Reference: REG. No. W-0296: Notice in accordance with Article 14(2) (b) (ii) of the Waste Management (Licensing) Regulations: Correspondence received 08th December 2017

KILSARAN CONCRETE
TULLYBANE QUARRY RESTORATION
KILMESSAN, CO. MEATH

QUARRY VOID MODEL - Void Survey Post Quarrying

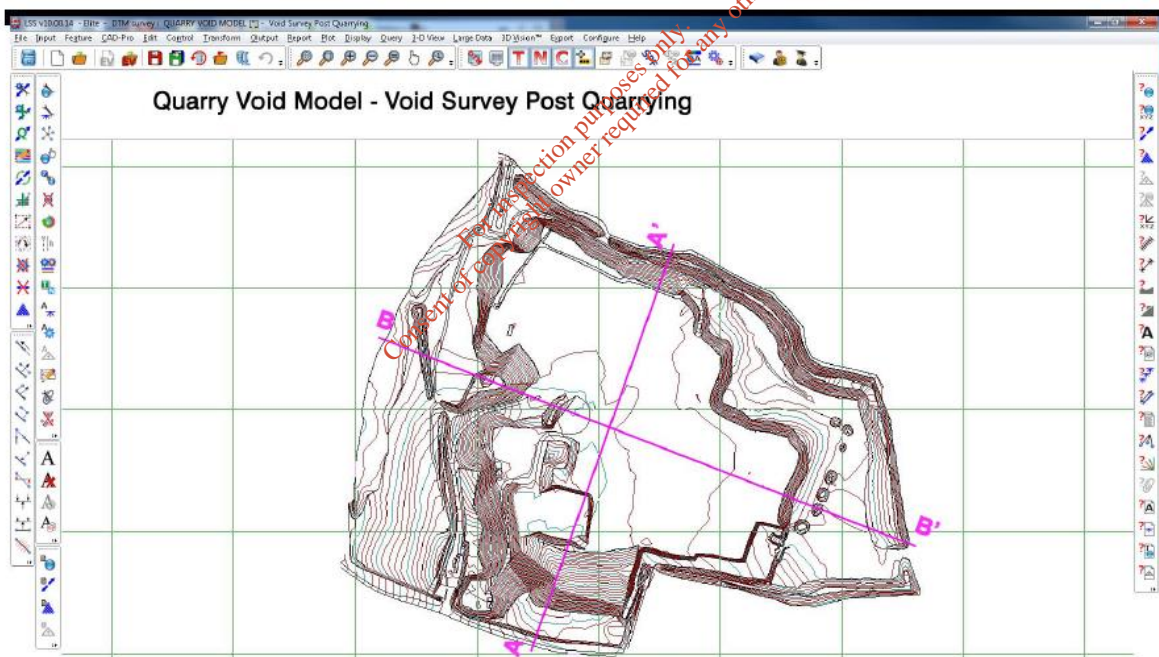
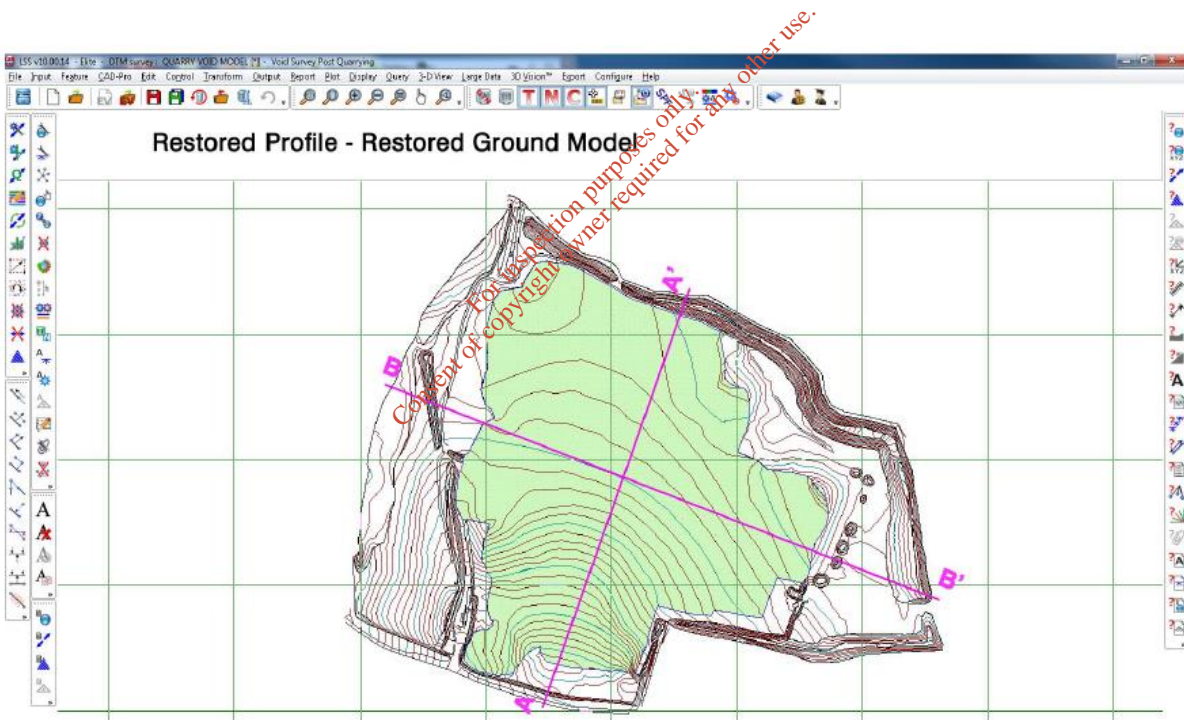
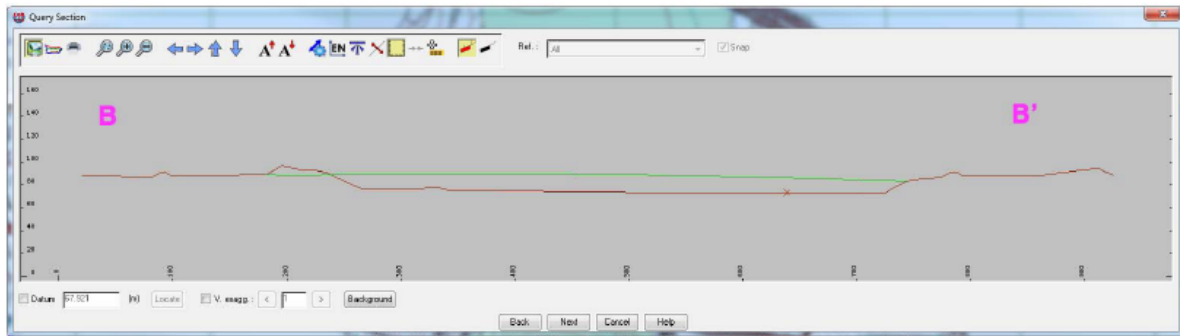
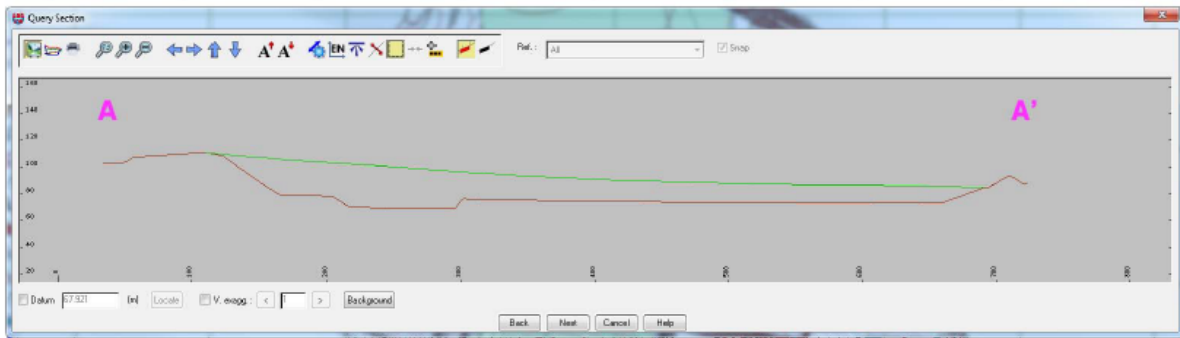
3. In relation to the stated volume of the void proposed to be filled (5.6 million m³), state the manner in which this was calculated.

Kilsaran Concrete utilised digital terrain modelling software called LSS from McCarthy Taylor Systems Limited to calculate the potential void volume. Topographic survey data was used to create a 3D digital terrain model (DTM) of the full site including the quarry void, as it stands following cessation of quarrying. A second DTM of the anticipated final backfilled landform was created in LSS. LSS compared the two triangulated DTM's and calculated the volume of the space between the two models. The reported volume of the void was 3,673,846 cubic metres. There follows a copy of LSS volume report giving the volume between these two models. Screenshots of the two DTM models with cross-section follow that.

The calculation of specific mass for the total volume required to fill the void was 1.5 tonnes per cubic metre thereby giving a total required volume of **5,510,769** tonnes required.

Taking the difference between the two calculation methodologies Method 1 - 5,556,800 and Method 2- 5,510,769 there is a difference of only circa 57,231 tonnes.

5. PROPOSED WATER MONITORING PLAN

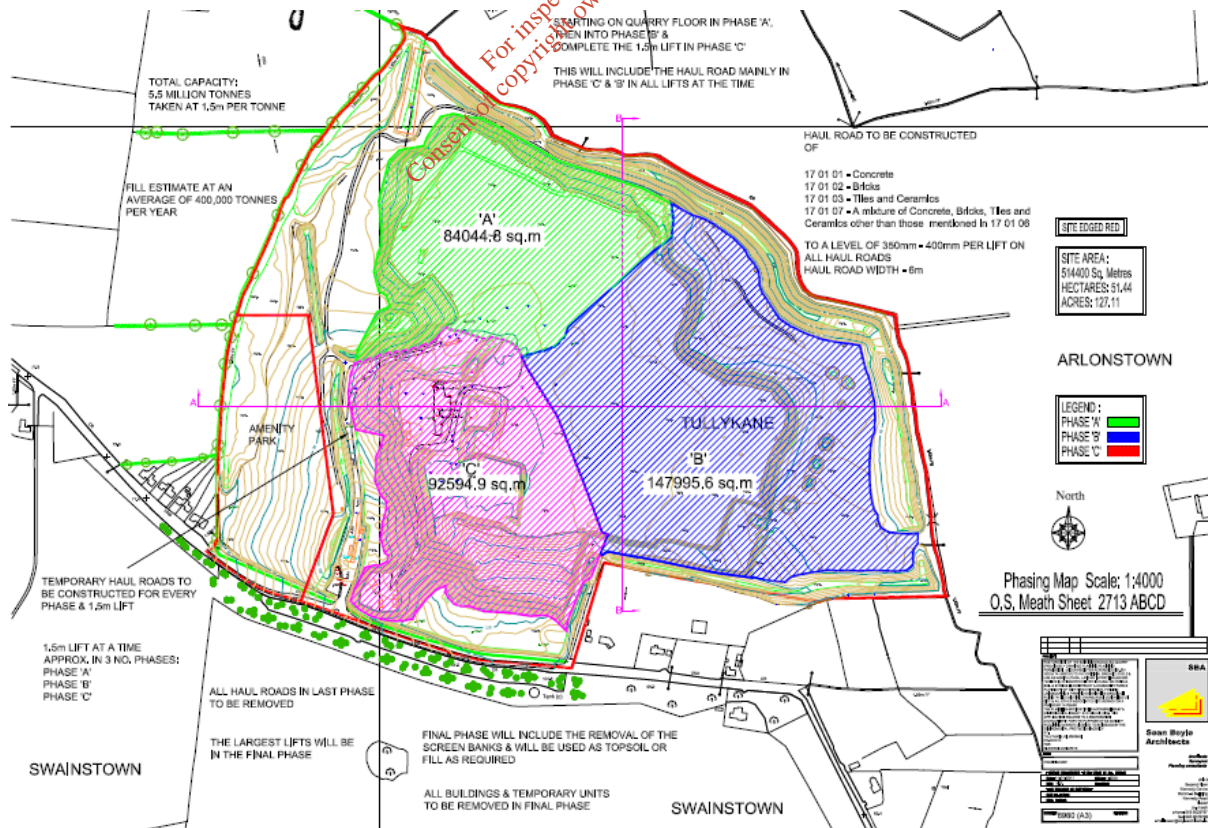
6. Provide a drawing showing existing and proposed new groundwater monitoring wells. Indicate on this drawing which wells are proposed.

I refer the Agency to page 31 of the Hydrogeology report as submitted with the Environmental Impact assessment for the planning permission and subsequently to the Environmental Protection Agency where the proposed Water Monitoring Plan is proposed.

Please also refer to Appendix 4 which is Figure 8 of same report which indicated the proposed locations of those proposed monitoring points

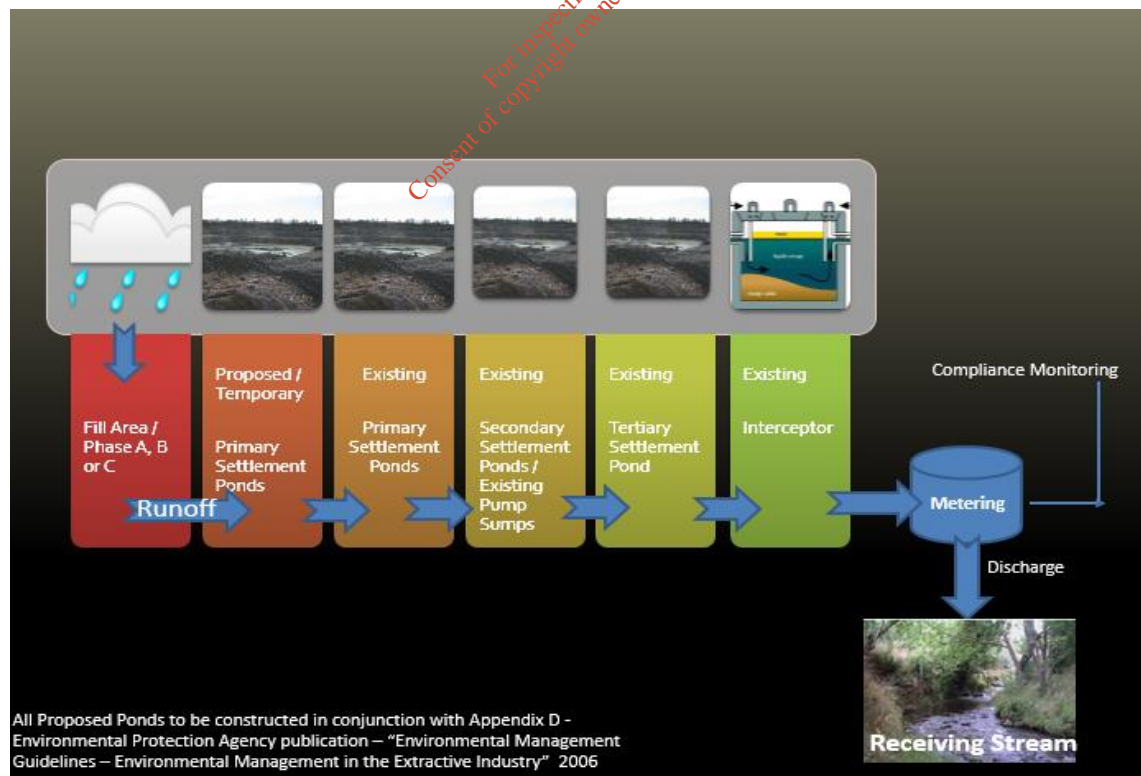
8. State the dimensions of the proposed settlement ponds. State the design objectives regarding flow velocity and removal of deposited sediment. Provide a drawing showing the location of these settlement ponds

In terms of the proposed settlement ponds and the objectives regarding flow velocity the first point of reference is to assess the proposed phasing plan as addressed in the EIS. Please see a screen shot below and reference Appendix 5 Phasing Map (6980 (A3)) attached.

From the proposed phasing plan there will be three very distinct production zones (Backfill zones) operational within the quarry restoration. In this vein it is thought that each zone will have a minimum of 1 but up to 3 distinct settlement zones. This is subject to design review and should be decided prior to commencement on site.

In terms of the design of the settlement of the ponds specific reference will be made to the Environmental Protection Agency publication – “Environmental Management Guidelines – Environmental Management in the Extractive Industry” Appendix D refers to the Design of Settlement Ponds. Given the nature of the material being brought to the site i.e. inert soil and stone 170504 and the very low projected levels of potential contaminants present the primary consideration is thought to be total solids and particle size. The exact levels and concentration of solids in the run-off will be very variable. The variation will be caused by the nature of the material used for infill, the level of compaction on site and the amount of rainfall prevalent at the time of working. The settlement pond design will have to be dynamic and as discussed above it is envisaged that there may be multiple settle ponds required.
